Re: Contract N62470-89-D-4814
Navy CLEAN, District III
Contract Task Order (CTO) 0160
Final RI/FS Project Plans
Operable Unit No. 10, Site 35
MCB, Camp Lejeune, North Carolina

**QUALITY ASSURANCE PROJECT PLAN
REMEDIAL INVESTIGATION/
FEASIBILITY STUDY**

**FOR OPERABLE UNIT NO. 10
(SITE 35)**

Final
**Responses to Comments from the Navy Environmental Health Center (NEHC) for the
Draft RI/FS Health and Safety Plan (HASP)
Operable Unit No. 10 (Site 35),
MCB Camp Lejeune, North Carolina**

FIGURE 4-1
PROJECT ORGANIZATION
RI/FS AT OPERABLE UNIT NO. 10
SITE 35
MCB CAMP LEJEUNE, NORTH CAROLINA

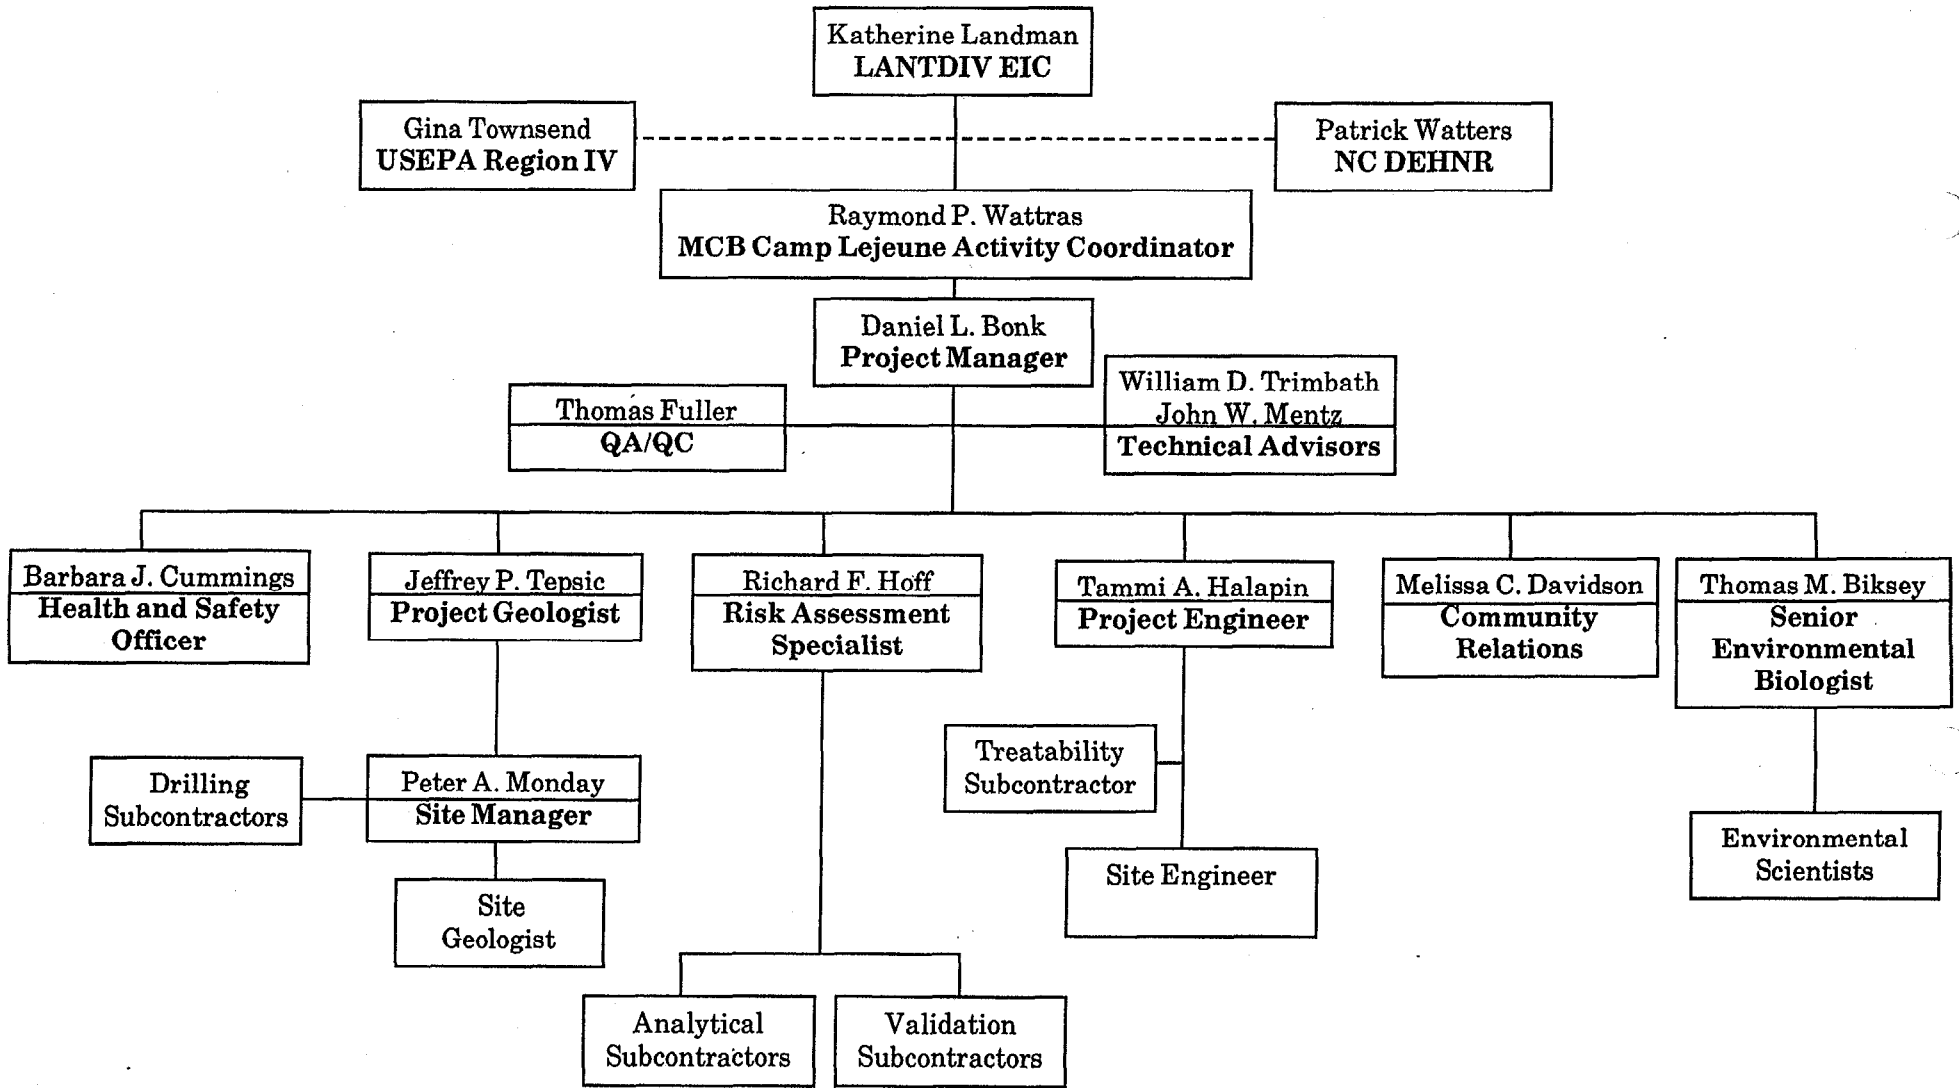
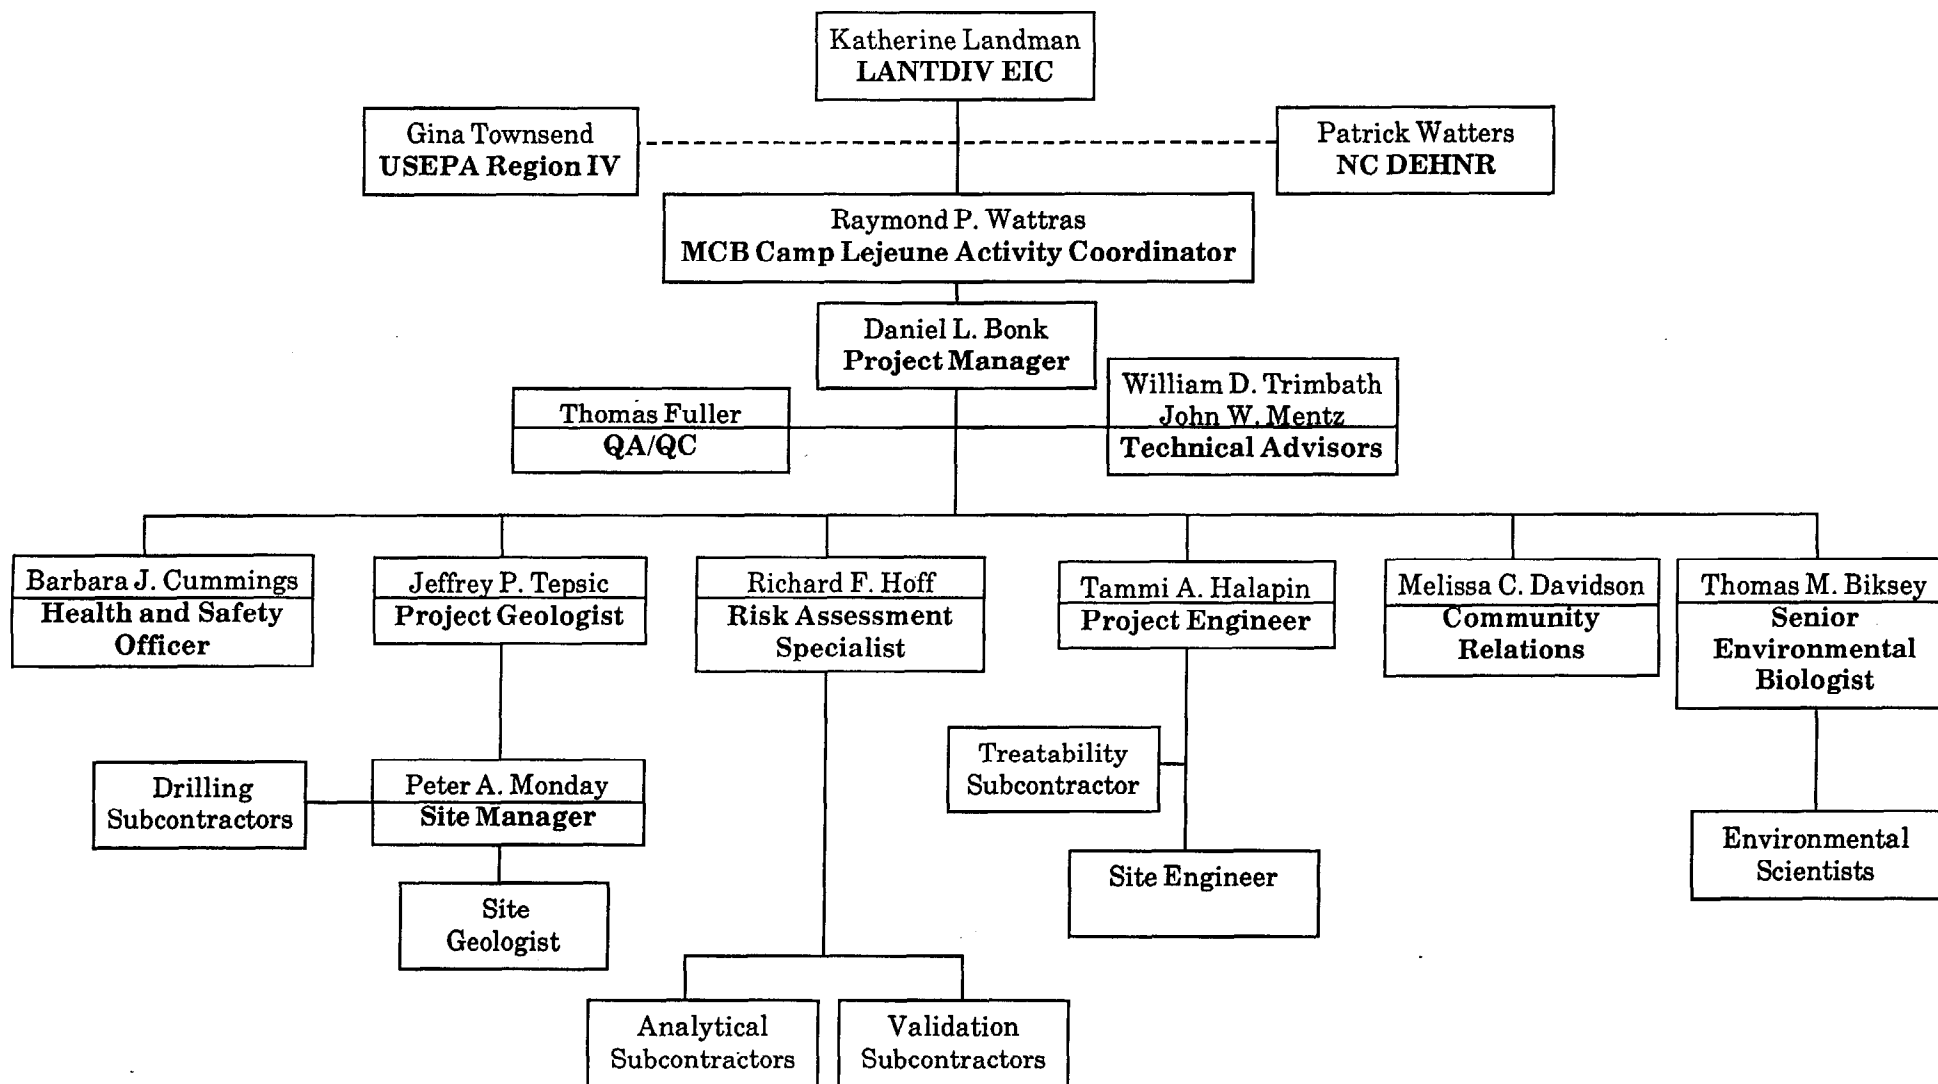
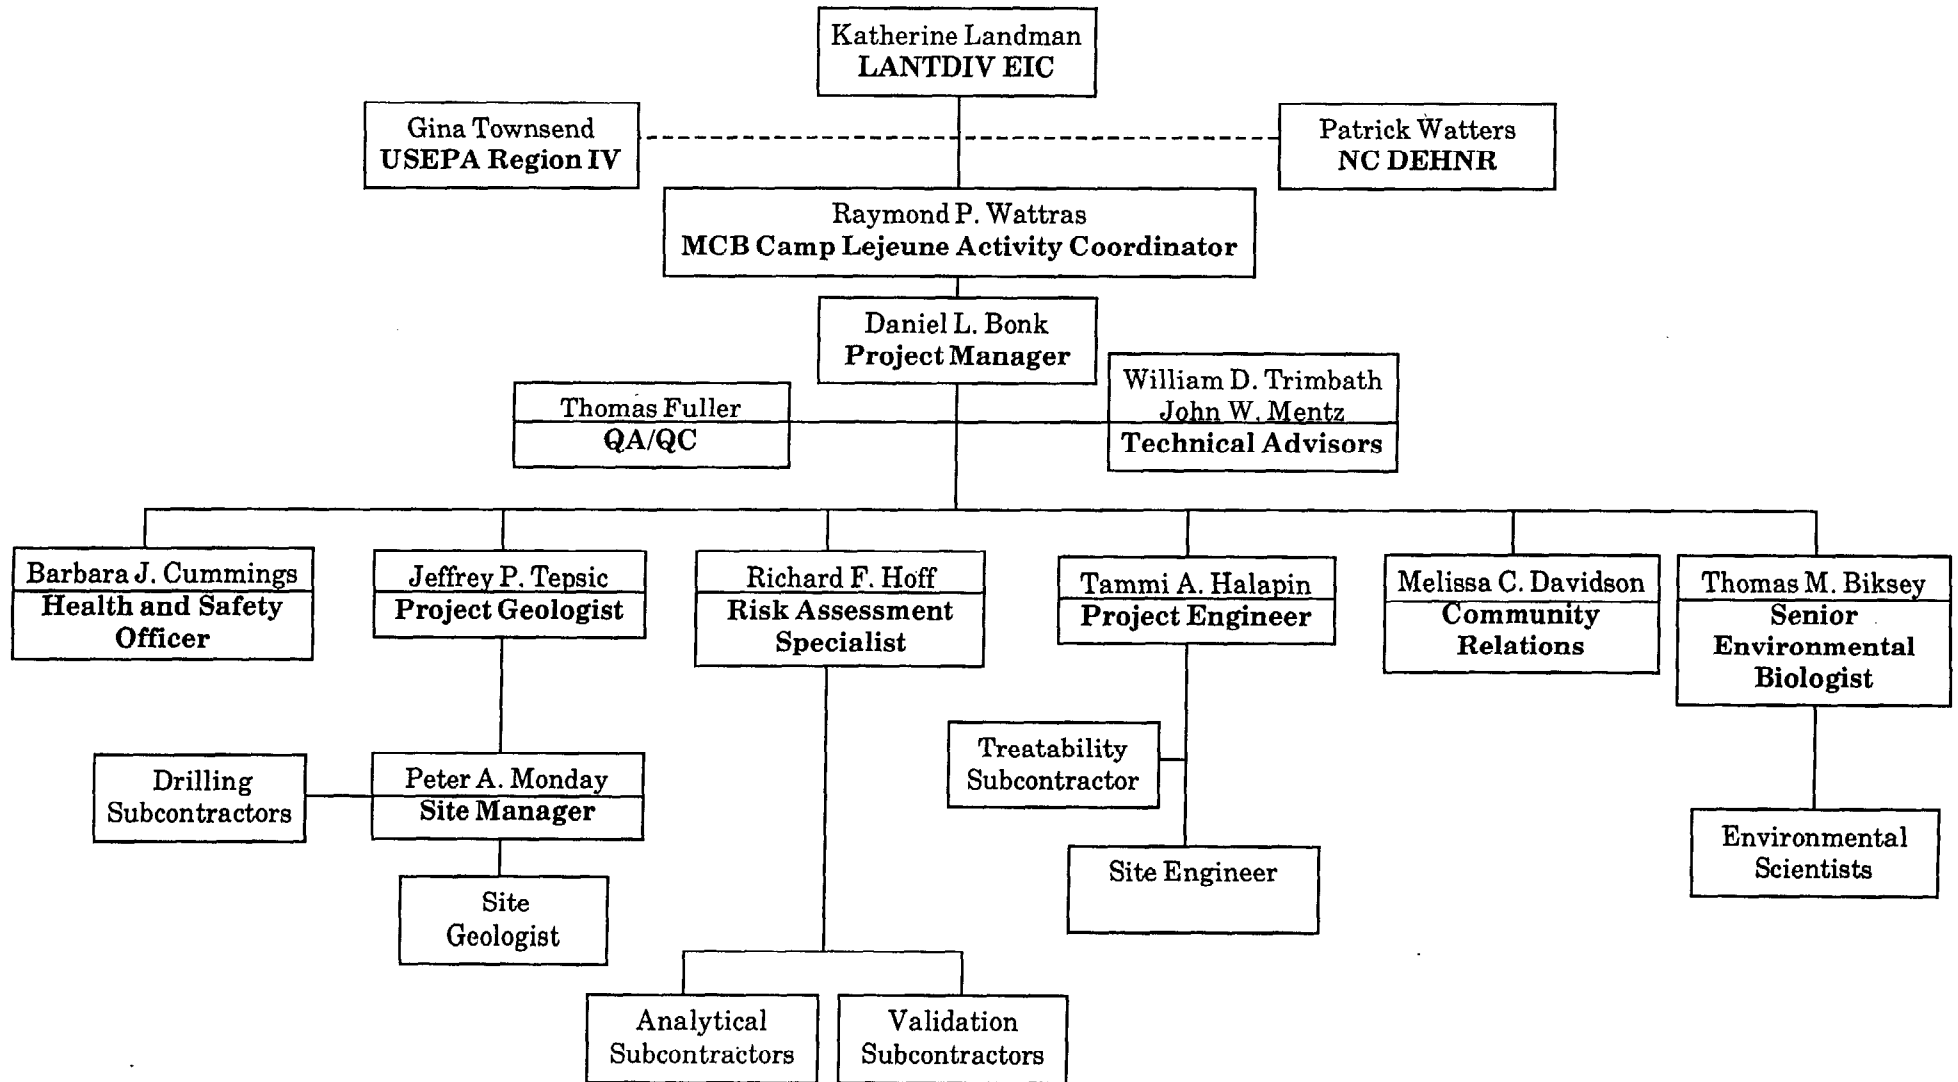
6. Page 4-2, Figure 4-1, Quality Assurance Project Plan

This figure needs to be updated to reflect the current organization for LANTDIV EIC, USEPA Region IV and NC DEHNR.

6. Figure 4-1 of the Quality Assurance Project Plan has been modified as per this comment.

FIGURE 5-1
TYPICAL DEEP ABOVE GRADE TYPE II GROUNDWATER
MONITORING WELL CONSTRUCTION DIAGRAM
SITE 35

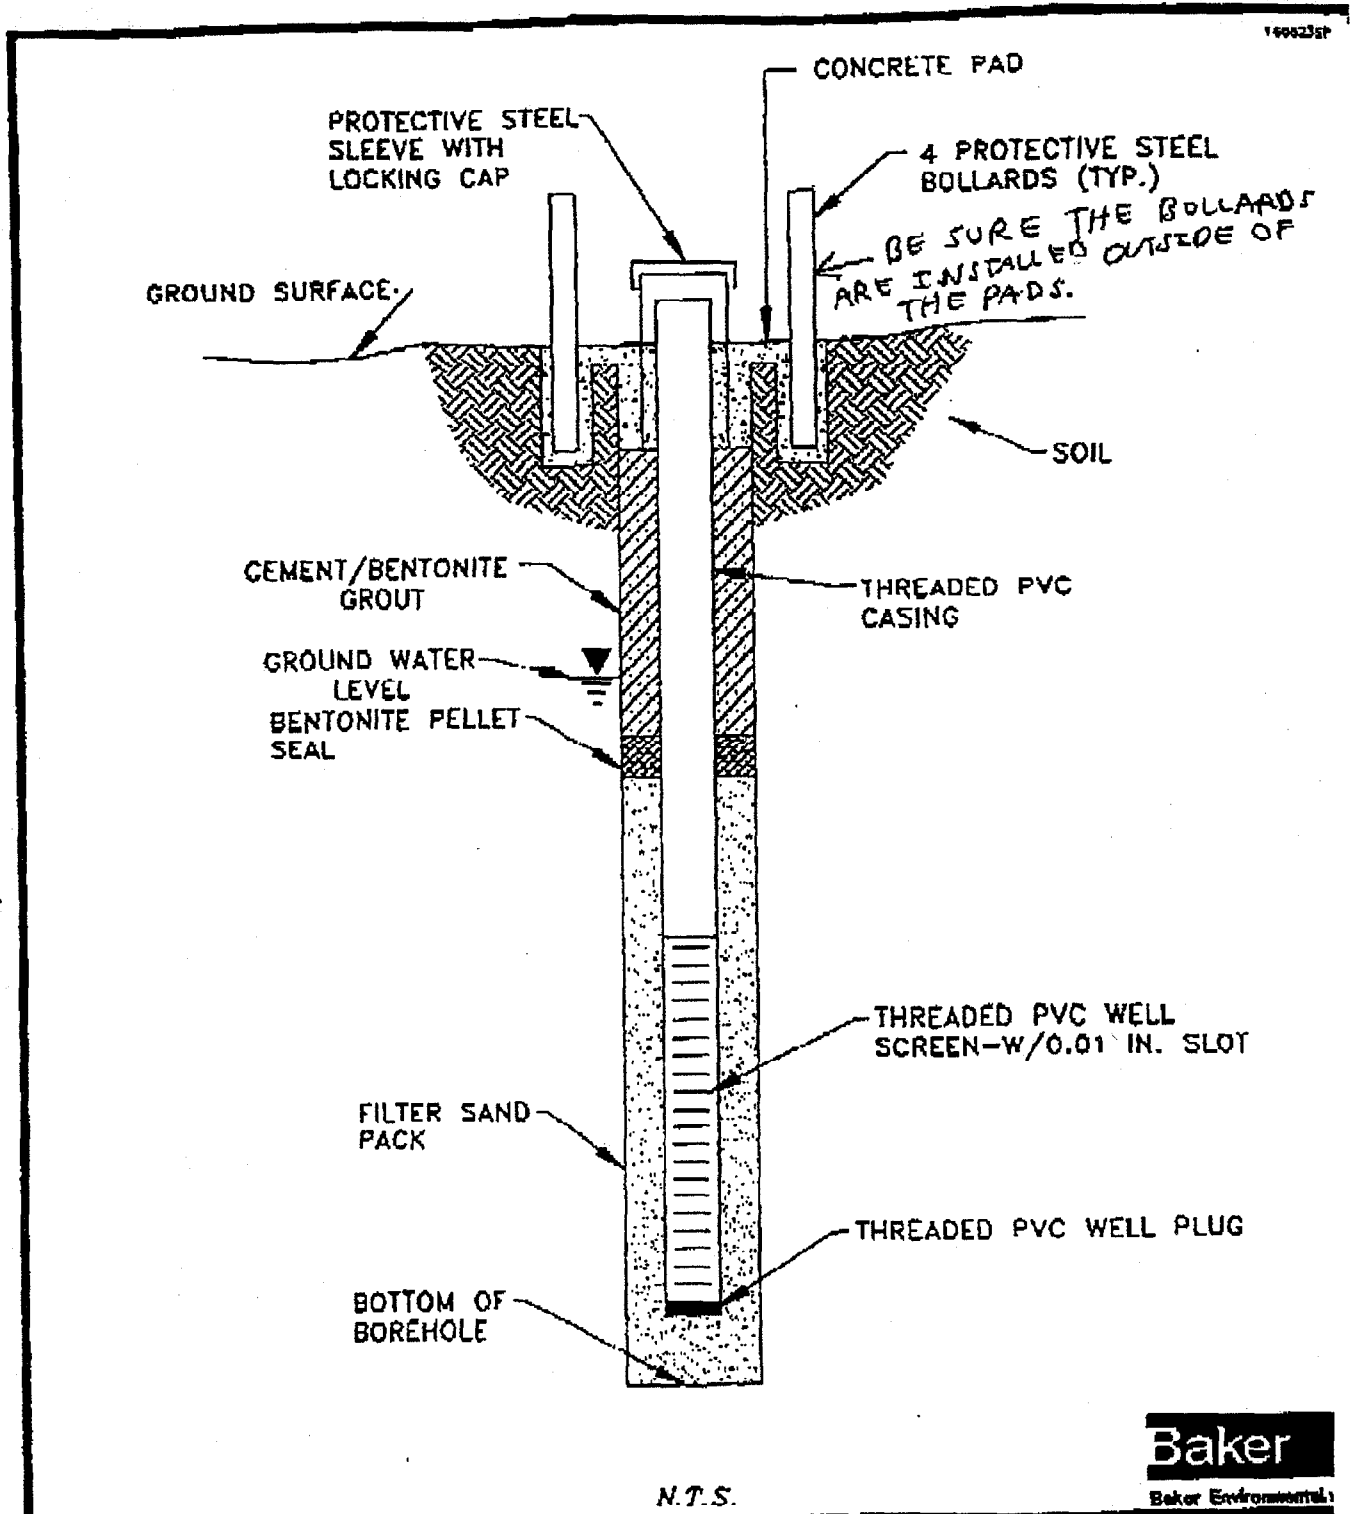
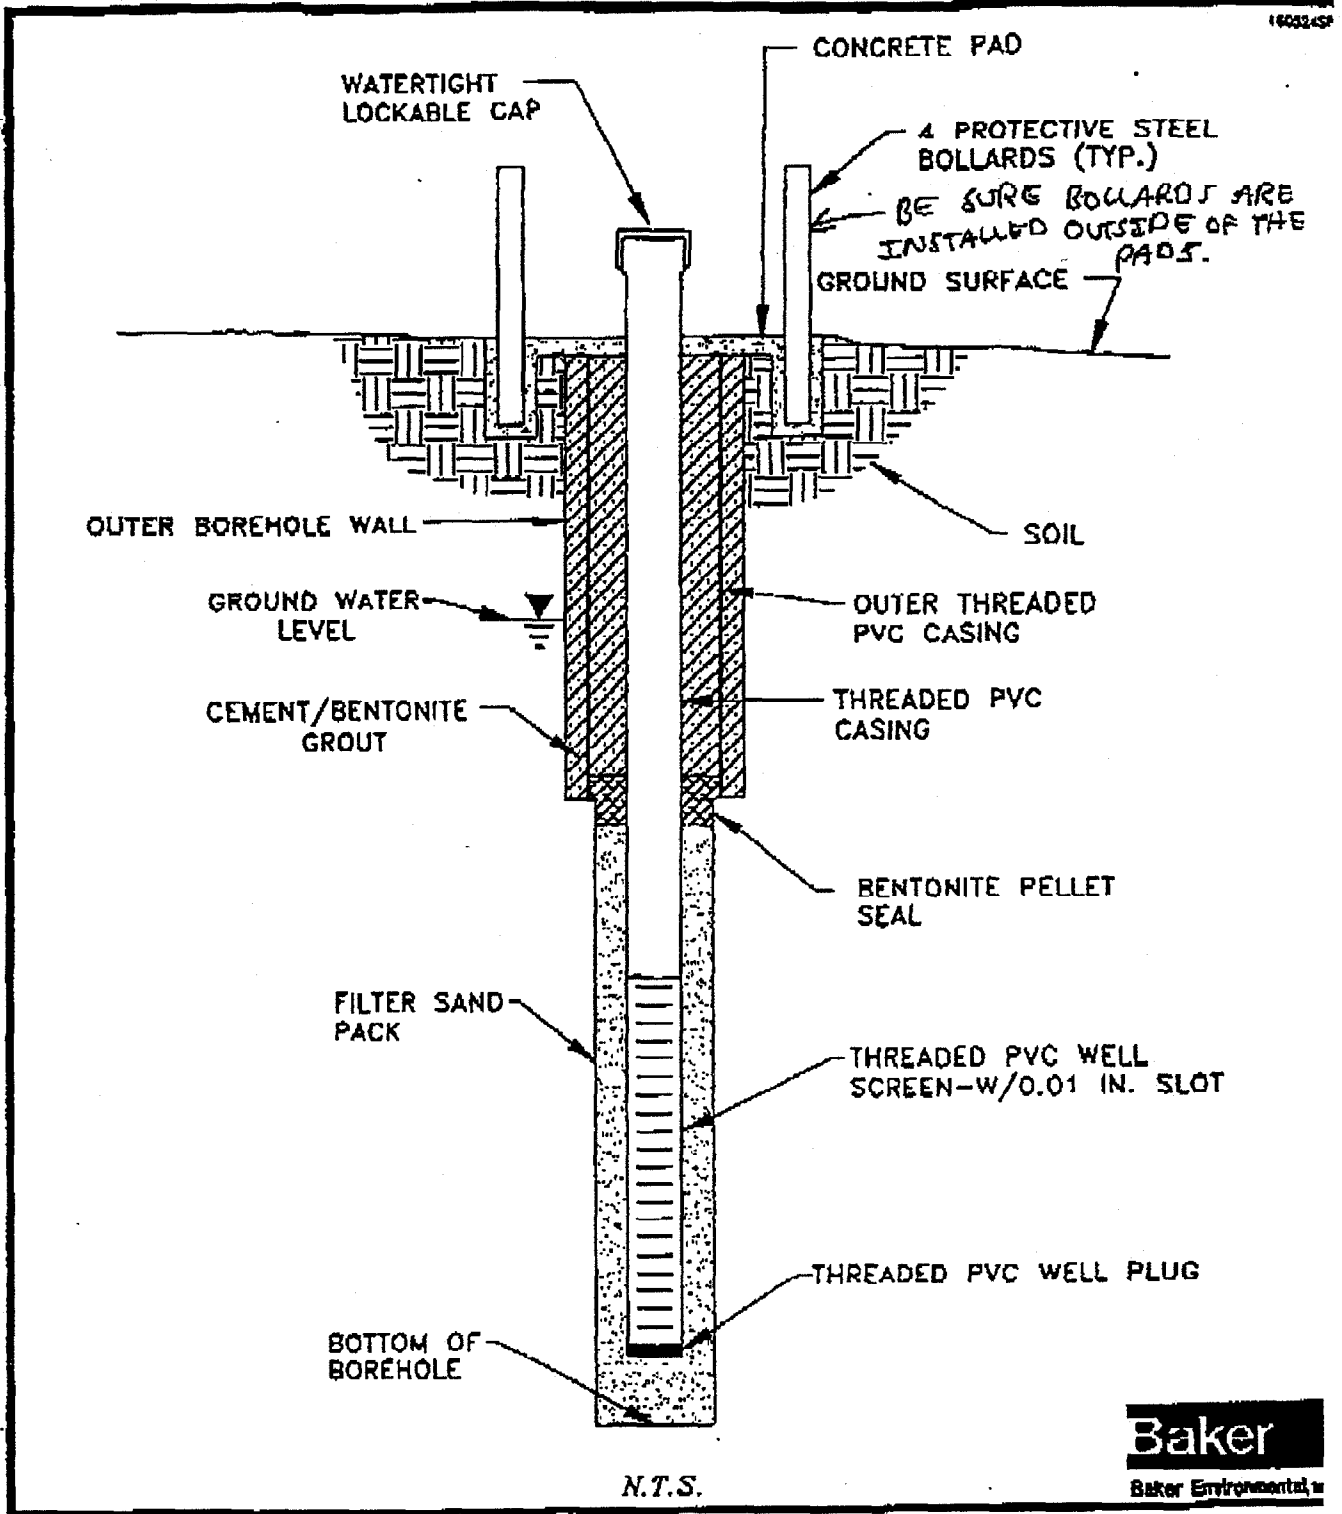
MODIFY PROCEDURE
BASED ON COMMENT
ON PAGE #5-4.

3. The title on the spine of the SAP has been modified as per this comment.
4. See Response Number 2.
5. The procedures for well installation in Section 5 have been revised to reflect the switch from double-nested wells to two-well clusters.
6. Figures 5-1, 2, and 3 have been modified as per this comment to indicate that bollards will be installed outside of the concrete pad into which the protective well casing is set.
